BELLAIRE PROPERTIES INC. (CARSON'S CREEK)
PURCHASER EXTRAS

LOT # 027 P.E #002 – Model - NIPISSING - 3210 - PHASE 5

Schedule B-3 – Purchaser’s Extras
forming part of the Agreement of Purchase and Sale

The nipissing / Elev. A & B
3210 sq.ft.

LOT 5-27, PH5, PE002

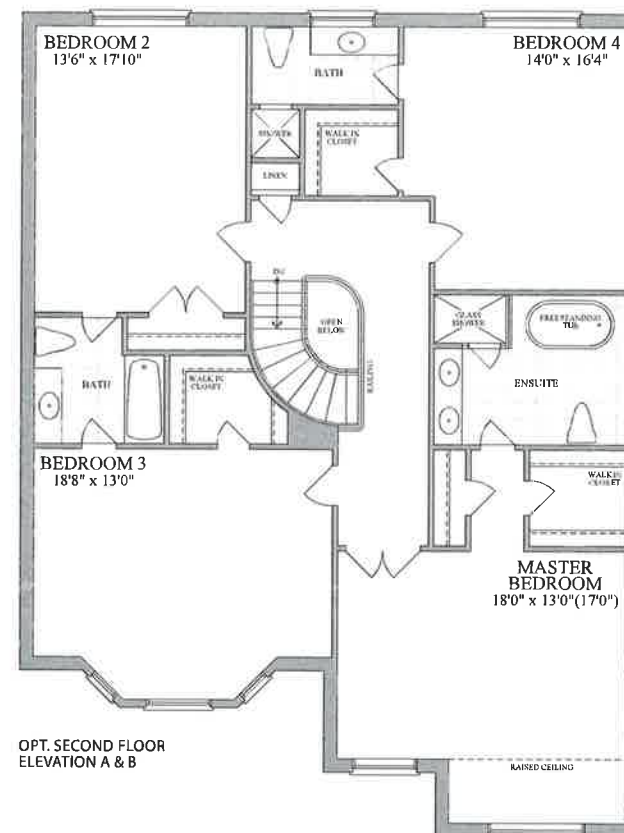
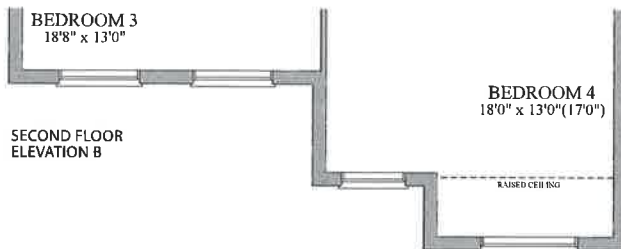
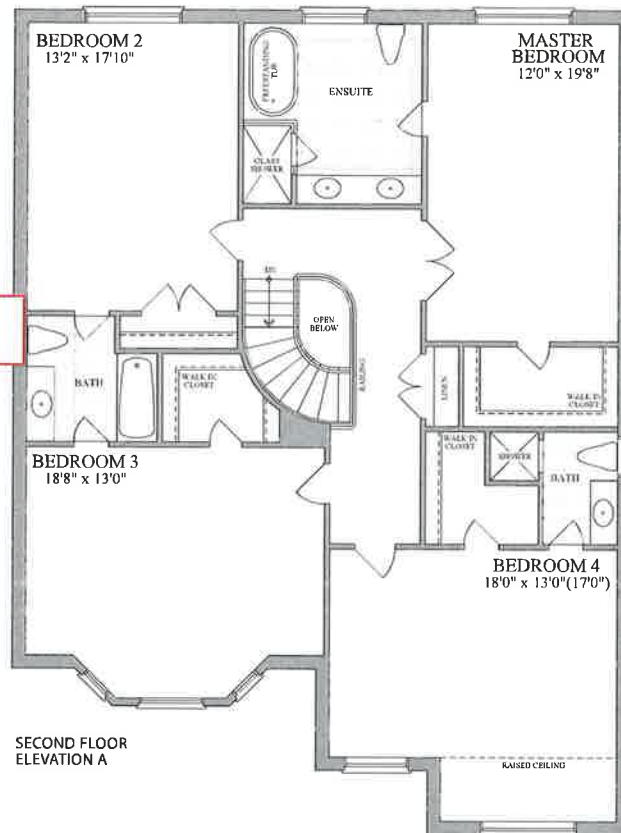
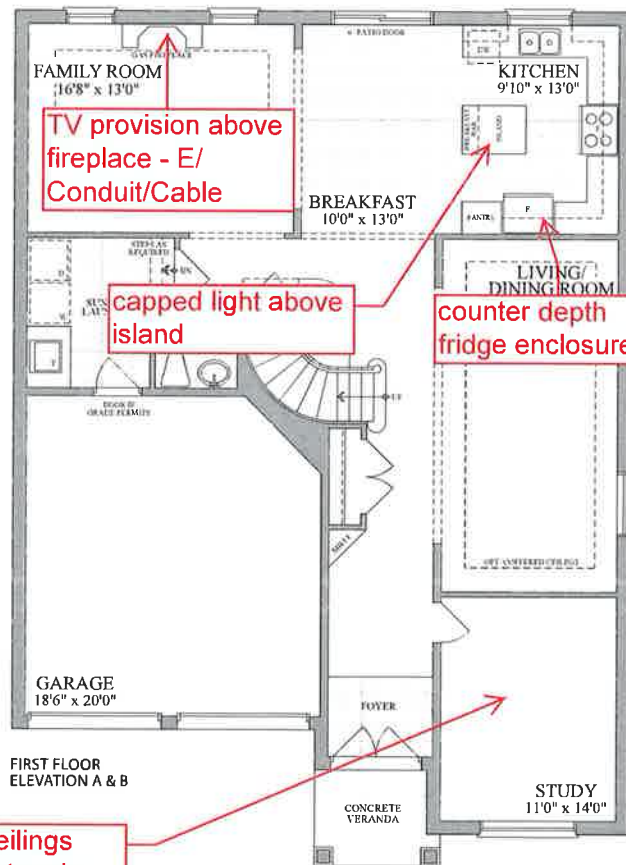
No.	DESCRIPTION	PRICE
1.	Provide "Conduit-only" in garage for future electric car charger	
2	Provision for wall mount TV above the fireplace. Includes dedicated electrical, conduit for future Tech Cable to floor receptacle and/or to end beside the fireplace. This does not include any brackets or mounting for TV

3.	Provide Counter-Depth Fridge Enclosure in kitchen area (counter-depth fridge cabinet, 65cm comes with 2 gables) in lieu of standard opening.	
4.	Provision for CHIMNEY HOOD FAN - Provision to cabinetry to accommodate future chimney hood fan/exhaust above future stove/range in kitchen area. Builder will try to accommodate centering the vent as best as possible. Purchaser must provide all specification for future chimney Style hood fan/exhaust fan as soon as possible. Some models require additional electrical requirements (in addition to standard) in which case additional charges may apply.

5.	Provide for smooth ceilings throughout the main floor	
6.	Basement Windows - Add one additional basement windows - standard size 30x20 white window frame. See sketch for Location

7.	Added capped ceiling light with own switch, above the kitchen island	
8.	Added "Rough-in Only" for future valance lighting with switch below upper cabinets in the kitchen area. (Price does not include light fixtures or kitchen valance moulding.	
Extra's Subtotal:		
H.S.T.		
New Total:		
Less Bonus Package (if Applicable)		(\$
TOTAL:		(\$
Balance of Bonus Package to be put towards the purchase of upgrades:		
TOTAL
